Promatic New 4 Pin Connector

E28V/4PFSH

This is the new connector Promatic will be using on all traps starting in January 2013. The new unit will offer enhanced weather resistance and performance.

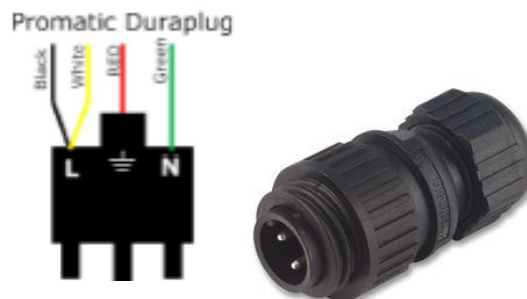
This connector has screw terminals and the wiring will be easy to switch from the Duraplug on your Promatic machine to this new connector.

1. Brown = 12 V+ will go to Pin 1
2. Green = 12 V- will be go to Pin 2
3. Blue = Trigger will go to Pin 3
